HyNet North West Carbon Dioxide CO2 pipeline consultation due by 22nd March 2022.

## Response to Hynet consultation

## HyNet Consultation comments

Our suggested route shown in blue line from circled points A to B

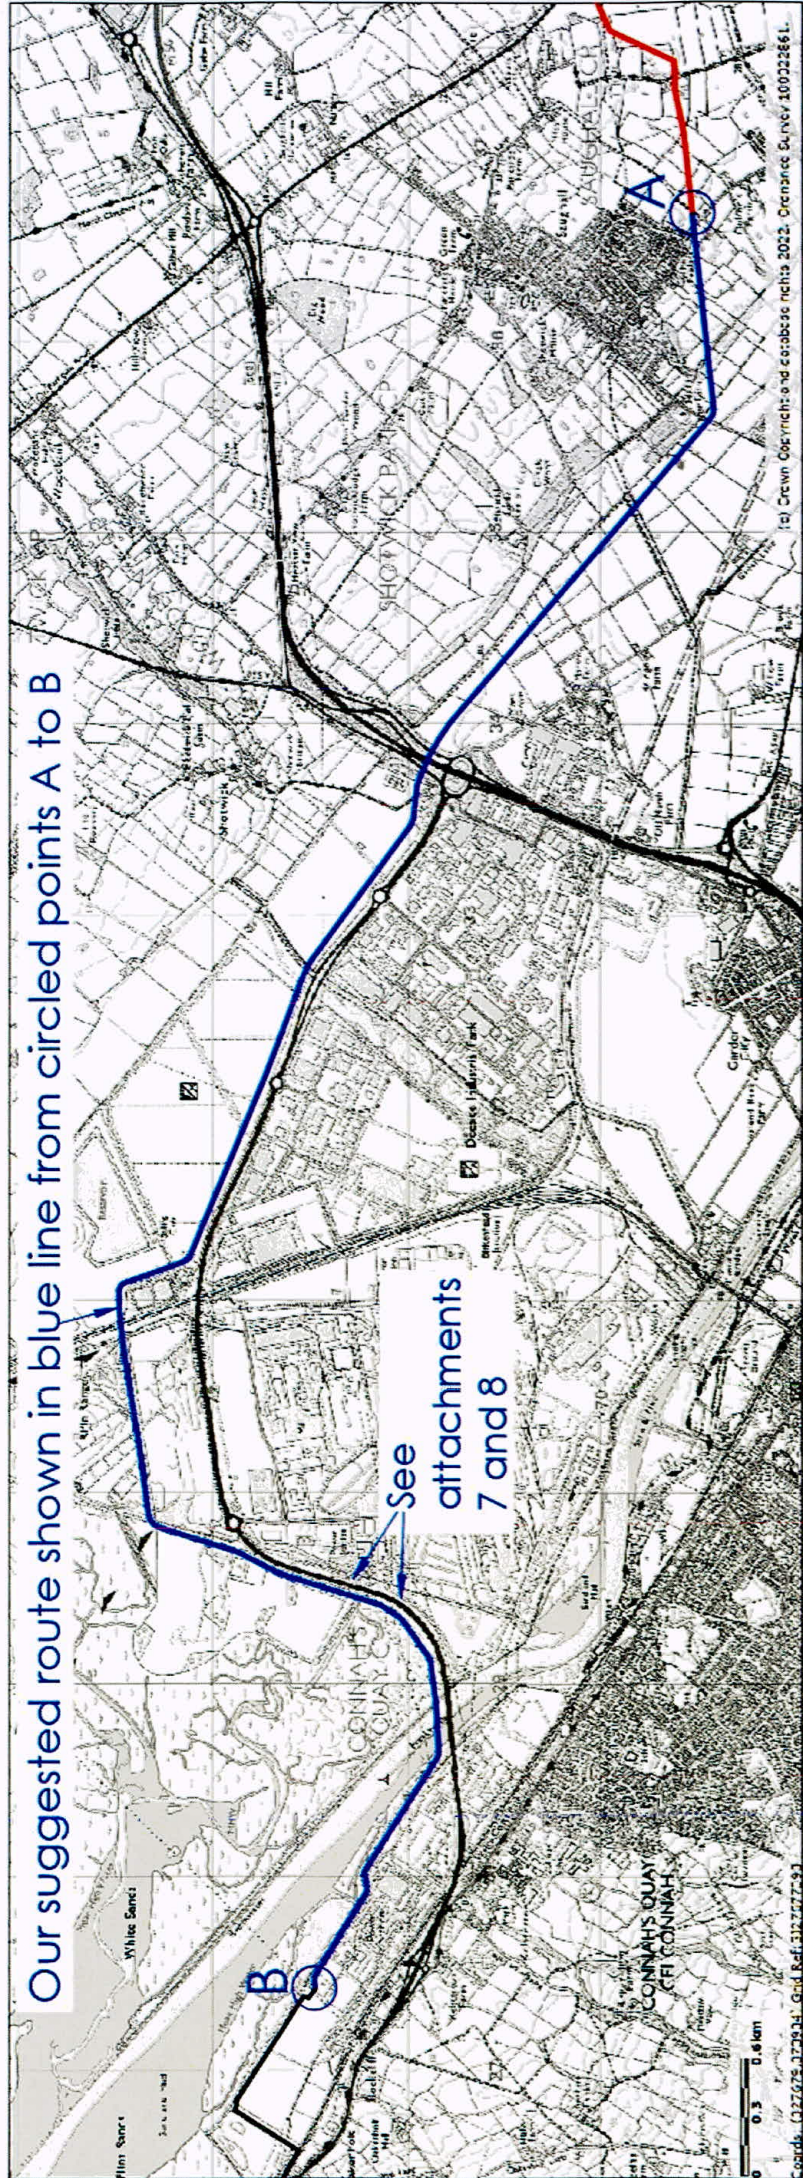
1. I am writing as a director of Shotwick Land Limited to suggest an alternative route for the Hynet CO<sub>2</sub> pipeline from a point just before where the preferred route crosses in a westerly direction into Wales up to where it connects with the existing pipeline. Our alternative route is shown coloured blue on the plan in Attachment 1.

We think that an alternative route running through the Northern Corridor should be preferred to Options G and I.

This alternative route (shown as a yellow line on the indicative plan below) diverges from Option I at a point approximately 17 kms west from the start at Ince. The route then proceeds west to just north of the roundabout at Drome Corner and crosses under the A494 to the start of Shotwick Road on the A548 which leads into Weighbridge Road. The route runs parallel with the A548 (Shotwick Road and Weighbridge Road) alongside the Flintshire Bridge and joins up with the existing pipeline to the west of Deeside Power Station. Most of this alternative route is via open or agricultural land except for a small section around Deeside Power Station.

Originator		<b>BOREHOLE RECORD</b> Scale 1 : 50 For explanation of symbols and abbreviations see Key Sheet	<b>WINPEY GEOTECH</b>
Checked & Approved			
DEESIDE ROAD LINK - RIVER CROSSING		fig. 2/61

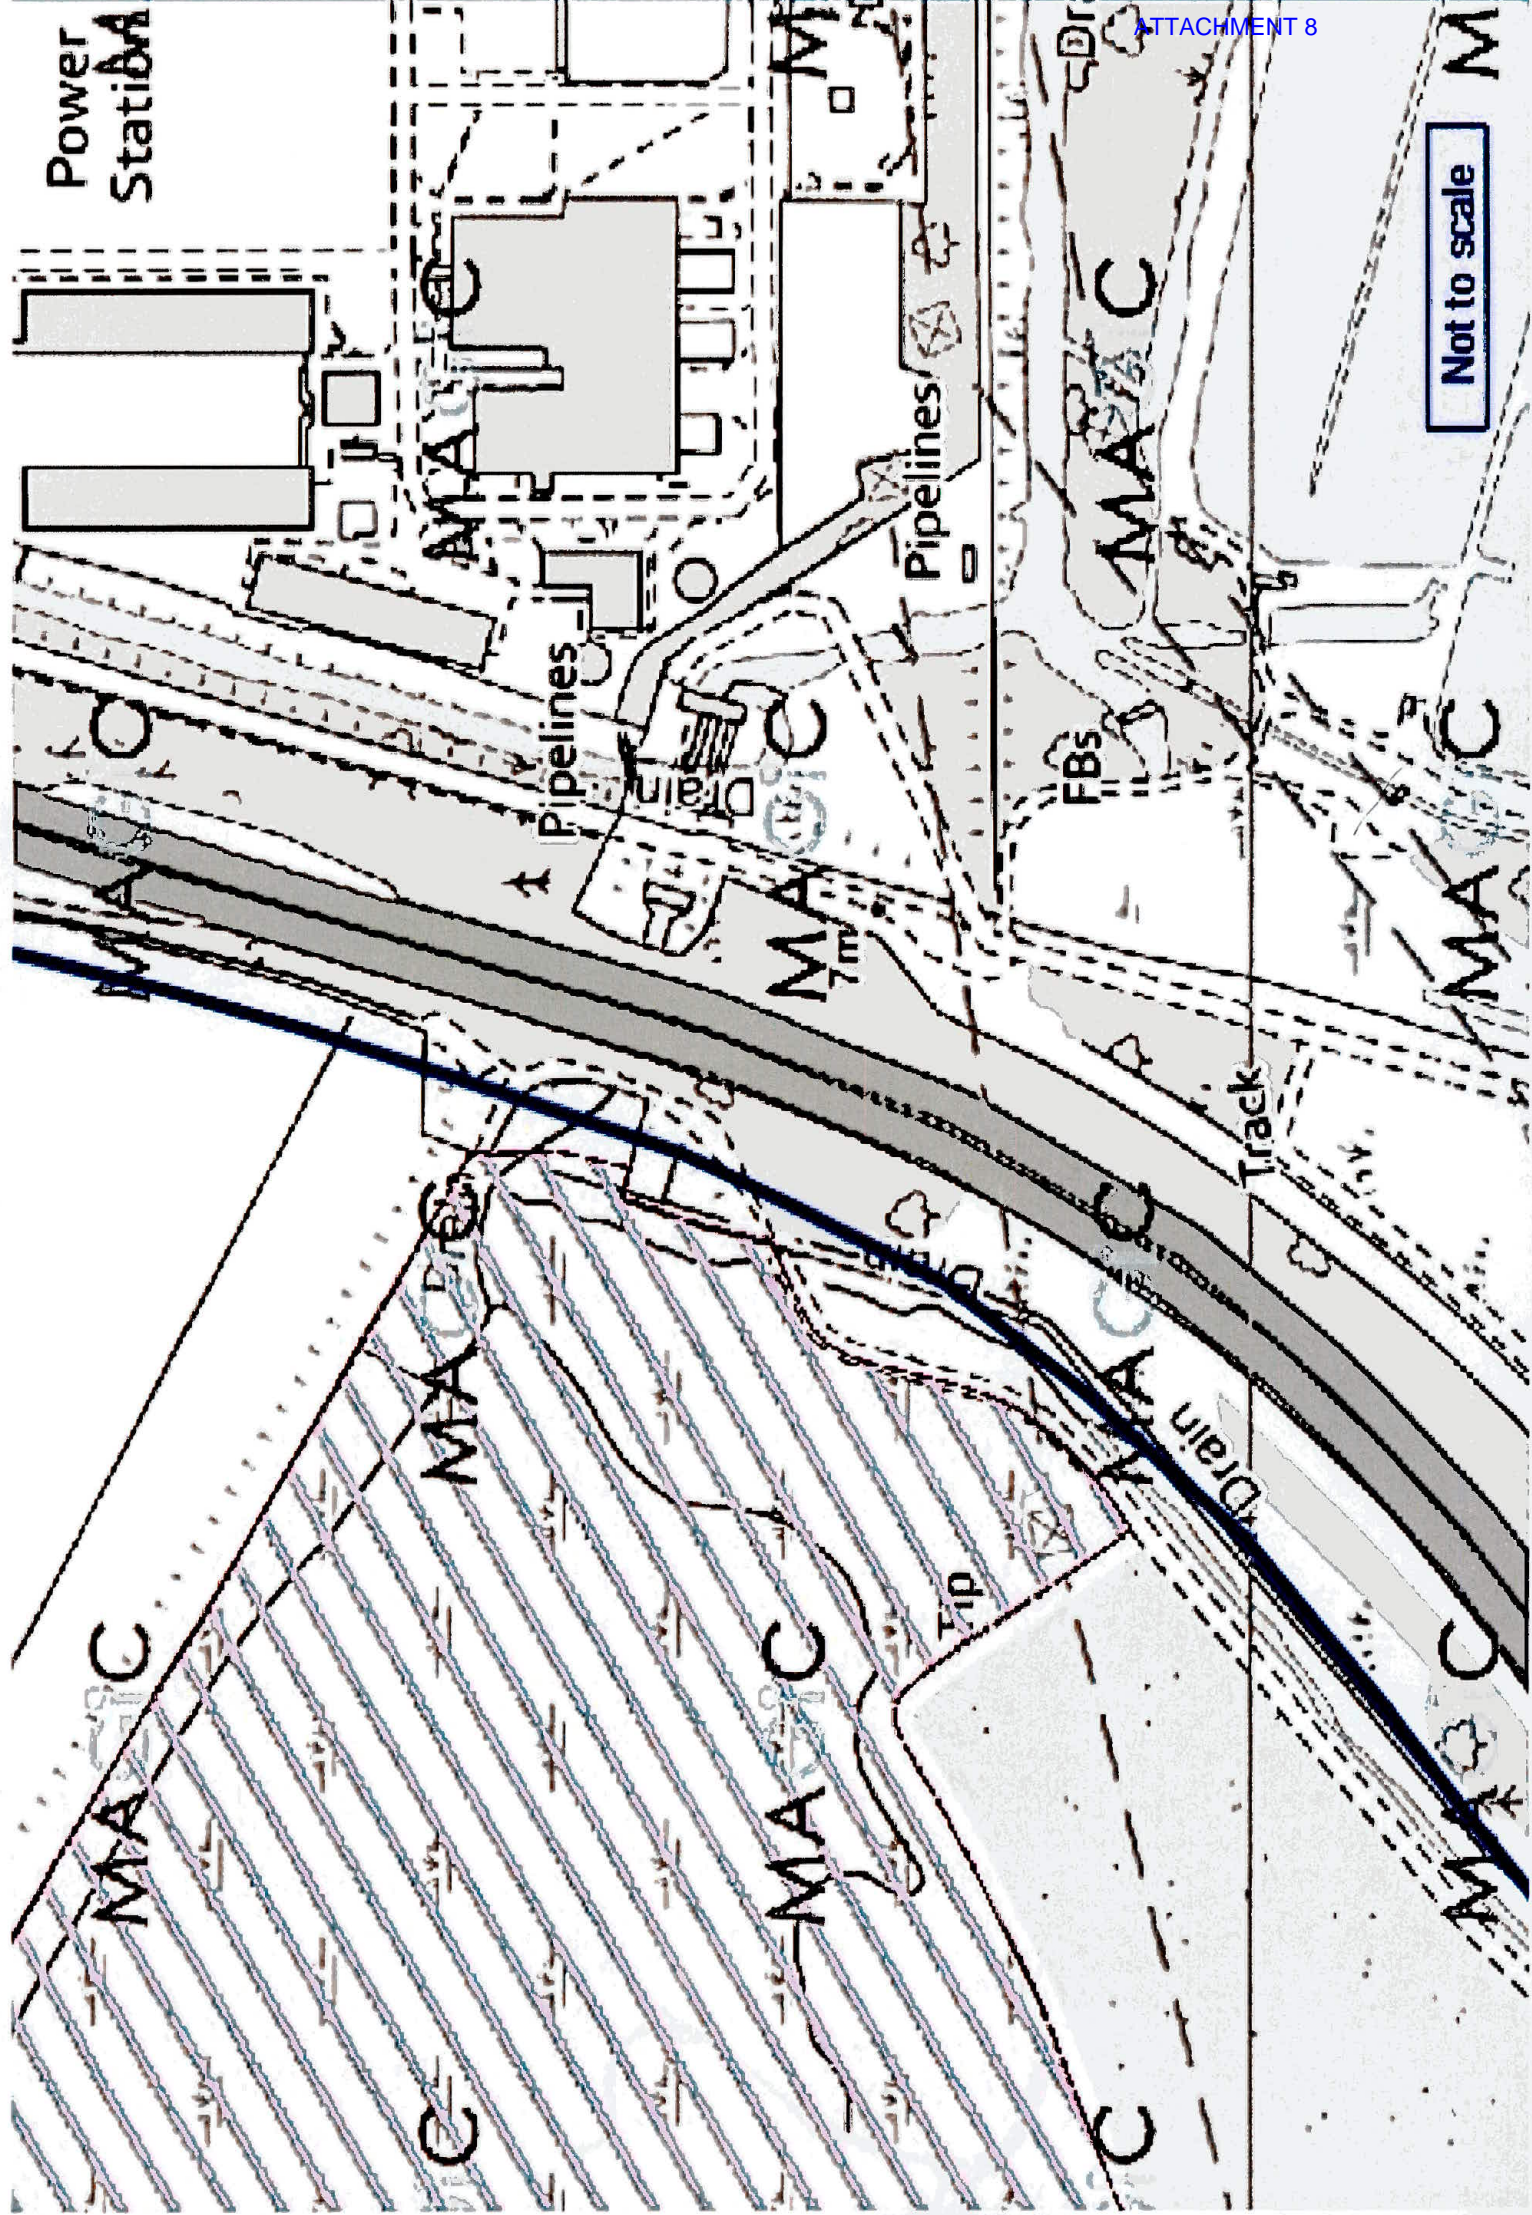
4. WSP maintain that the adverse geological conditions on both banks of the River Dee where our suggested route crosses the river militate against choosing our route. In particular, they say that "the crossing itself is understood to be built on shifting sands". By "crossing" we assume that WSP mean the Flintshire Bridge. Clearly, the bridge cannot have been built on shifting sands; if it had been, it would have collapsed by now. Instead, the bridge's foundations are resting on solid ground.

5. At the risk of stating the obvious, it must be possible to use horizontal directional drilling ("HDD") to take the pipe through ground which is strong enough to carry the pipe under the river, even though that may well be at some depth. As far as I can ascertain from the websites of HDD operators, even if that depth were to exceed 100 metres, using HDD would still not be a problem. For information, I attach as Attachment 6 page 1 of the drilling record of a borehole drilled in the middle of the River Dee in May 1990, from which you will see that sandstone is present at a depth of 7.65 metres. In other words, of course it will be possible to drill under the River Dee to take the pipeline to the other side of the river.
